Access Compliance Report

Public Rights-of-Way

Intersection ID: 11690	Main Street: AIRLIE_ST	Cross Street: JEFF_ST	Location: E
ADA ID: 4925B41BFDD4	Ramp Type: BlendTrans1	Initial Pass/Fail: Fail	Overall Compliance: No
		Severity Score: 10

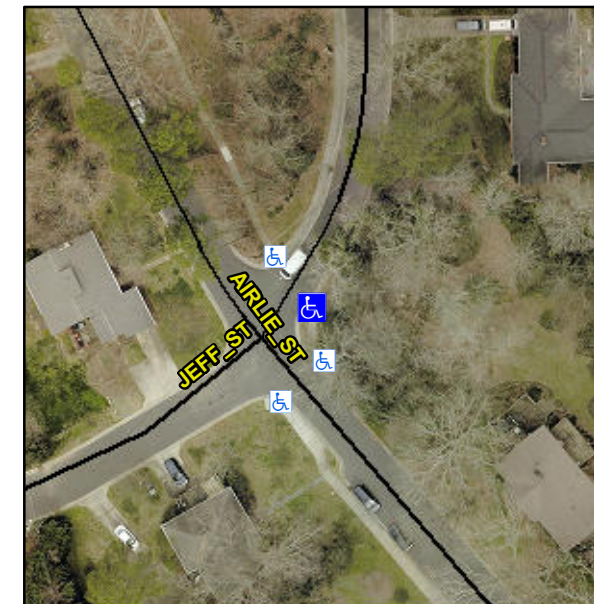
Not Found, R304.5.1, R304.5.3

Compliance	Description	Data	Compliance	Description	Data
N/A	Ramp Length (in)	49.0	Yes	BlendTrans Slope (%)	3.7
No	Ramp Width (in)	46.0	No	BlendTrans XSlope (%)	3.1
N/A	Flare Type LT	N/A	N/A	Flare Type RT	N/A
N/A	Flare Slope LT (%)	N/A	N/A	Flare Slope RT (%)	N/A
N/A	Flare Traversable LT?	N/A	N/A	Flare Traversable RT?	N/A
N/A	Landing Length (in)	N/A	N/A	DWS Provided?	N/A
N/A	Landing Width (in)	N/A	N/A	DWS Contrast?	N/A
N/A	Landing Slope (%)	N/A	N/A	DWS Length (in)	N/A
N/A	Landing X Slope (%)	N/A	N/A	DWS Full Width?	N/A
N/A	Landing Curb? (Y/N)	N/A	N/A	DWS Offset (in)	N/A
N/A	Shared Landing?	N/A			
N/A	Gutter Ponding?	N/A	N/A	Gutter Slope (%)	N/A
N/A	Gutter Lip Ht (in)	N/A	N/A	Gutter X Slope (%)	N/A
N/A	Painted X Walk1?	No	N/A	Painted X Walk2?	N/A
	X Walk 1 Direction	To NW		X Walk 2 Direction	N/A
	X Walk 1 Width (in)	N/A		X Walk 2 Width (in)	N/A
	X Walk 1 Slope (%)	2.2		X Walk 2 Slope (%)	N/A
	X Walk 1 X Slope (%)	2.9		X Walk 2 X Slope (%)	N/A

N/A	Ramp inside XWalk1?	N/A	N/A	Ramp inside XWalk2?	N/A
	Road Slope (%)	2.9		Clear Space?	N/A
	Road X Slope (%)	2.2	N/A	Clear Space to XWalk (in)	N/A
N/A	Any Obstructions?	N/A	N/A	Storm Grate/Utility Hazard?	N/A
	Obstruction Type			Storm Grate/Utility Type	
		N/A			N/A
			Yes	Surface Condition? (G/P)	Good
			No	Curb Slope (%)	16.1

Remove & Replace Curb Ramp With Two New Directional Ramps or Equivalent.
